**TOWN OF GRAFTON
CAMBRIDGEPORT BRIDGE**

Town Of	GRAFTON	Bridge No.	16G
Highway No.	TH 1	Log Sta.	
		Surv. Sta.	
TH 1 (CAMBRIDGEPORT BRIDGE) OVER THE SAXTONS RIVER			
BEAM ELEVATION			
Designed By	L. S. GARDNER	Drawn By	B. J. MASSE
Checked By	Date	Bridge Design Supervisor	
J. T. KLEIN	12/05	M. A. COLGAN	Date 12/05
PROJECT	GRAFTON	PROJECT NO.	TH2-0104
I.G.C. Info.		File No.	51335BE
		Sheet	31R of 42

THIS SHEET SUPERSEDES CONTRACT PLAN SHEET 31 DATED 6/05. REVISIONS ON THIS SHEET REFLECT CHANGES IN DESIGN AND DETAILS AS PER CHANGE ORDER NO. 2. SUBSTITUTING NEW STEEL BEAMS FOR RECYCLED BEAMS.

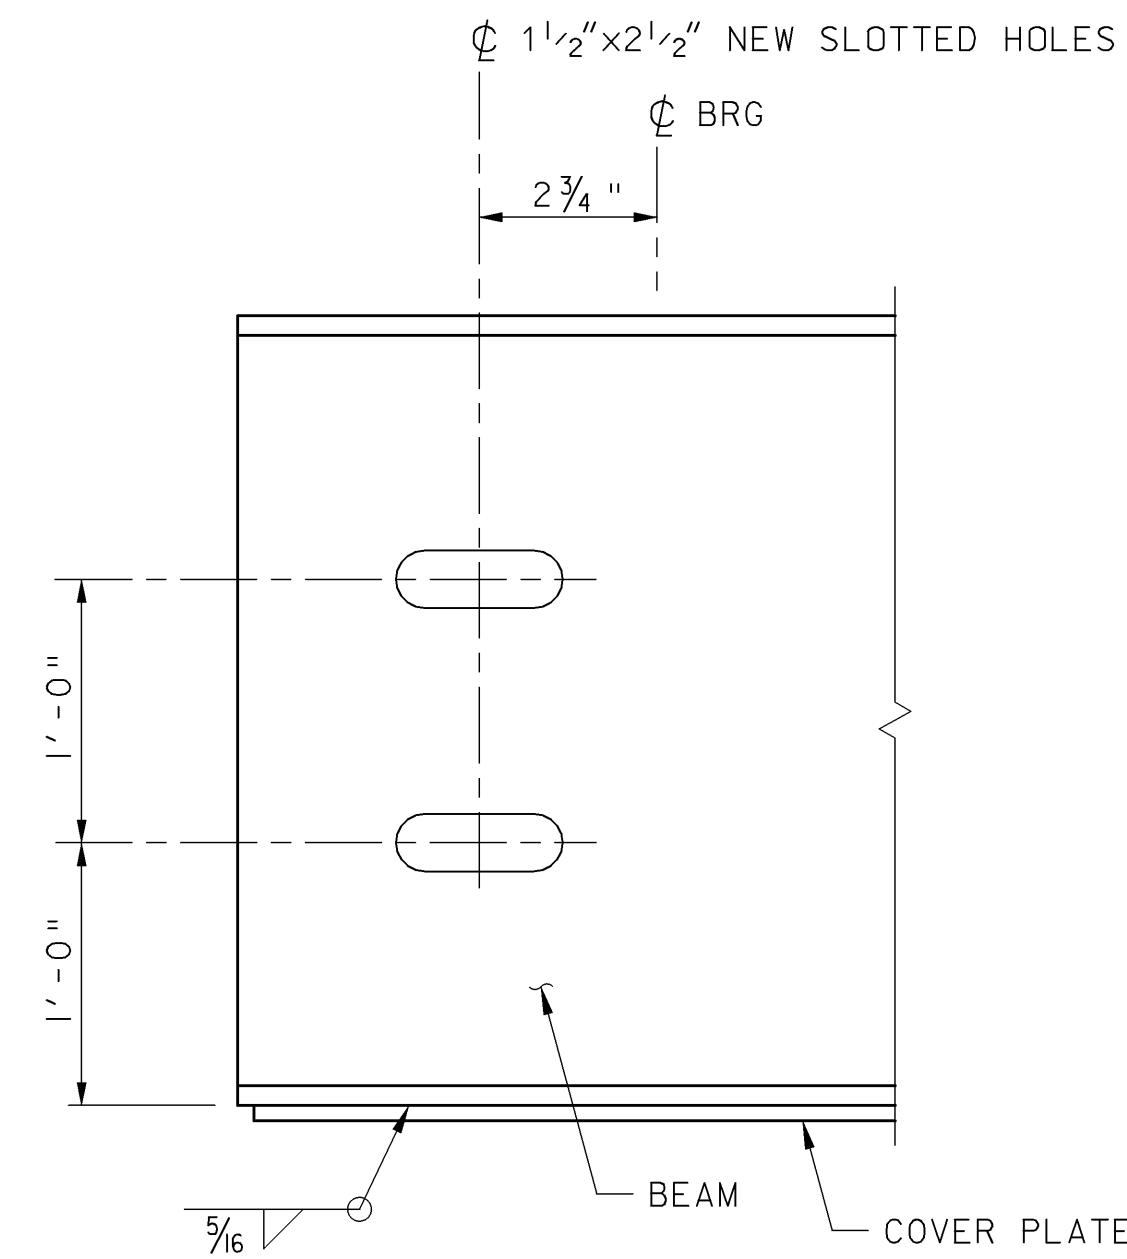
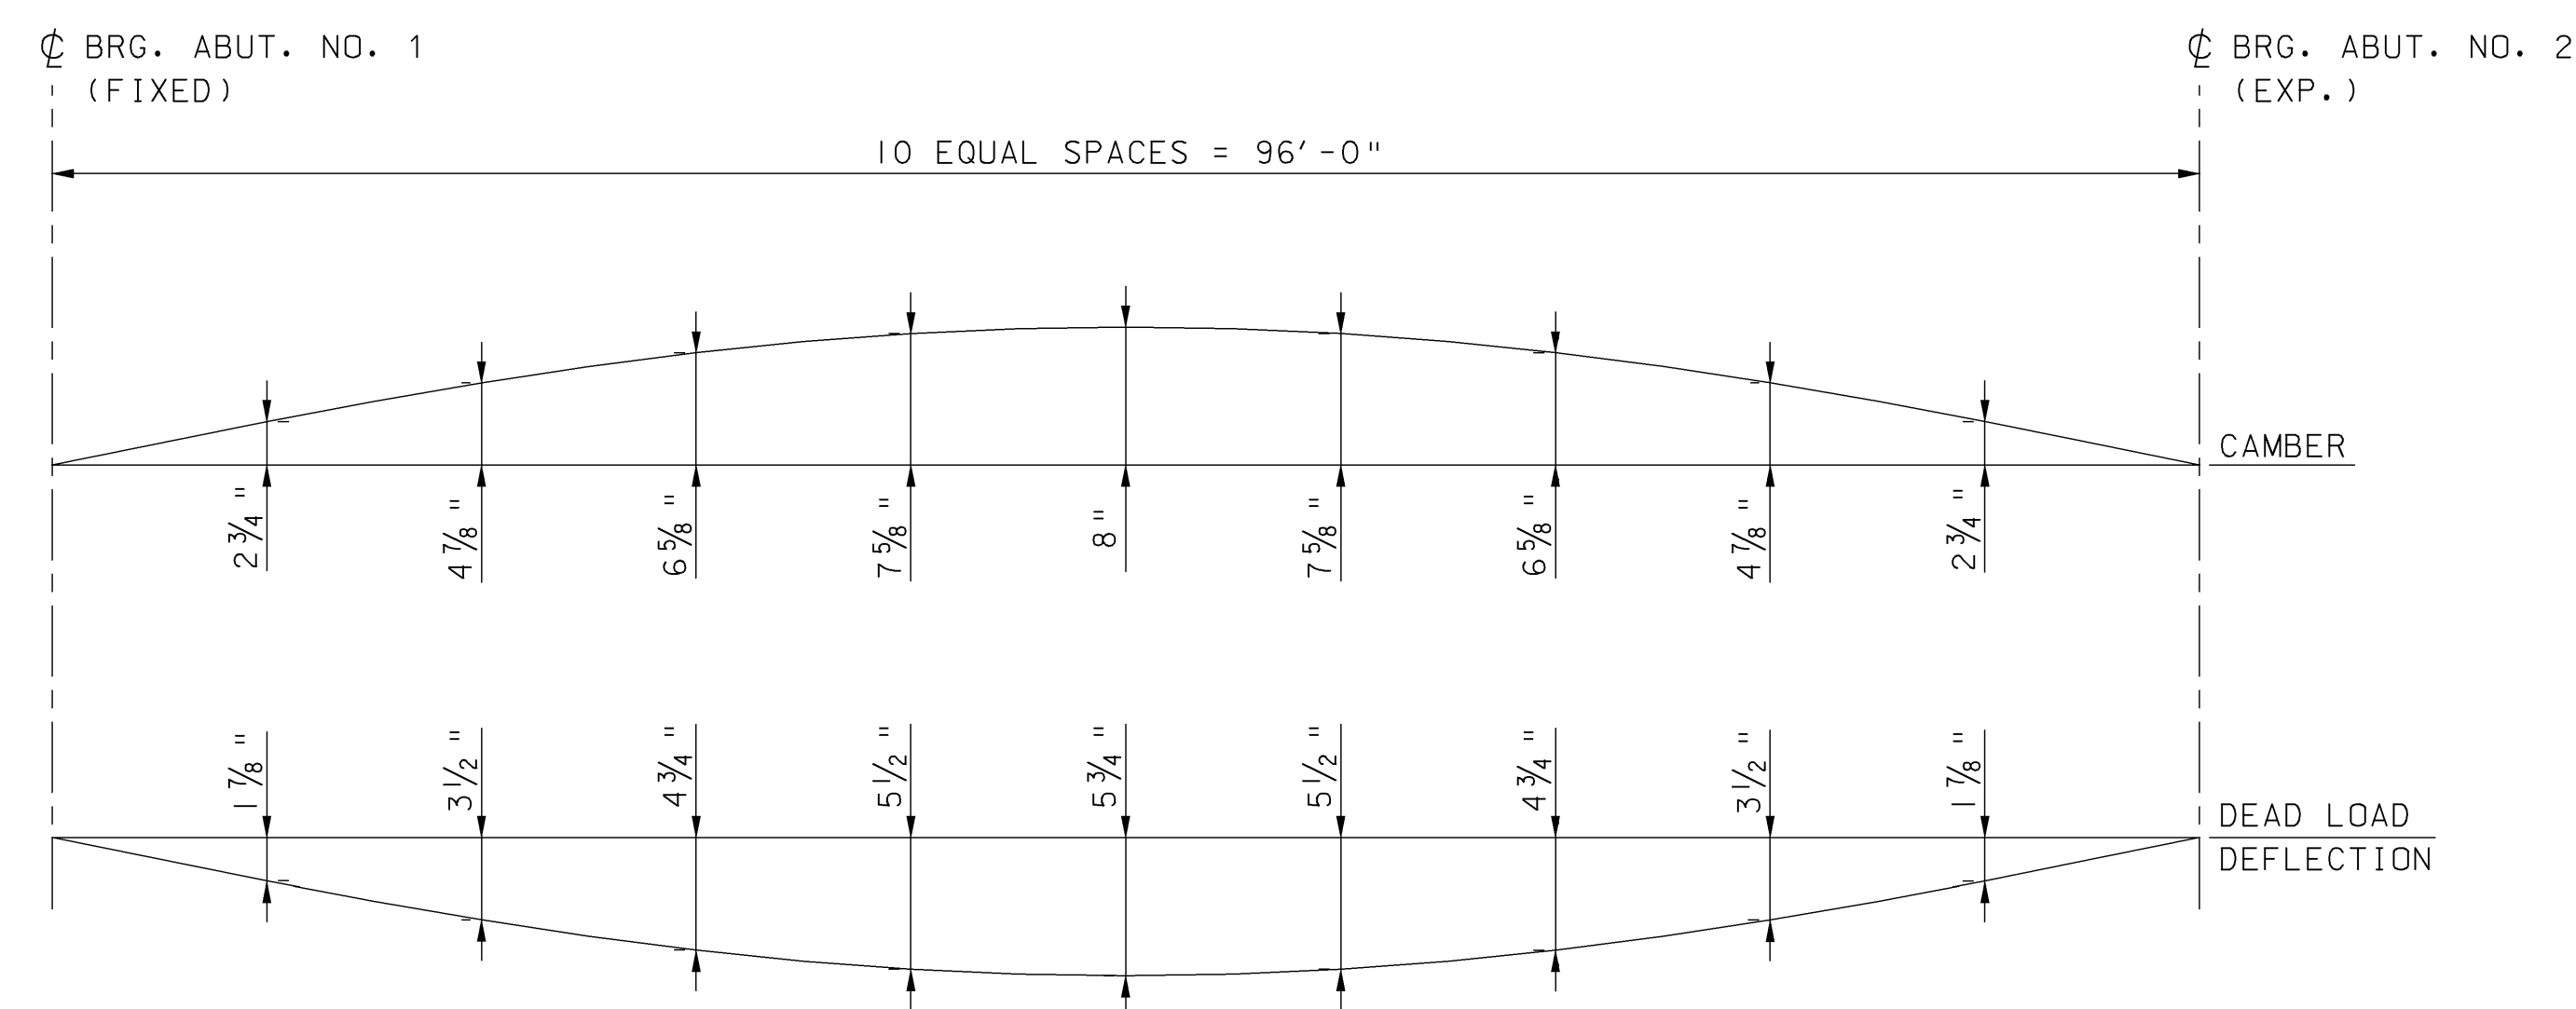
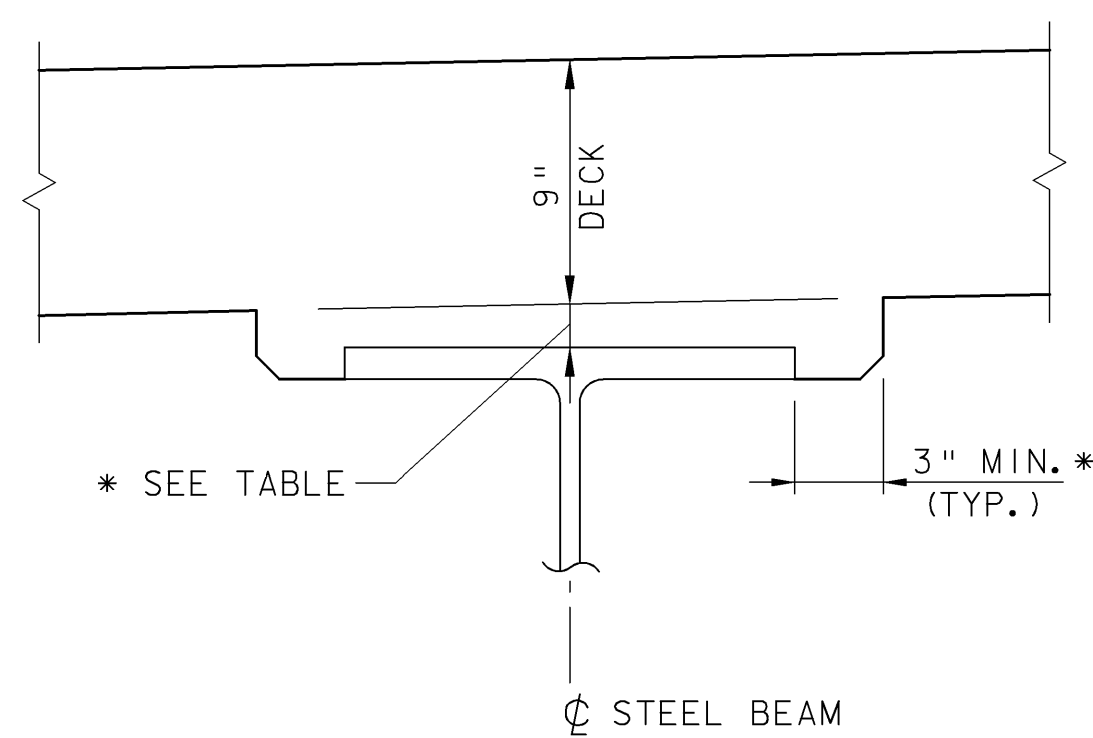
** TABLE INDICATES ANTICIPATED HAUNCH DEPTHS REQUIRED TO REDUCE BEAM CAMBER AS REQUESTED BY THE CONTRACTOR FOR CHANGE ORDER NO. 2. ACTUAL HAUNCH DEPTHS SHALL BE DETERMINED IN THE FIELD AS APPROVED BY THE RESIDENT ENGINEER.
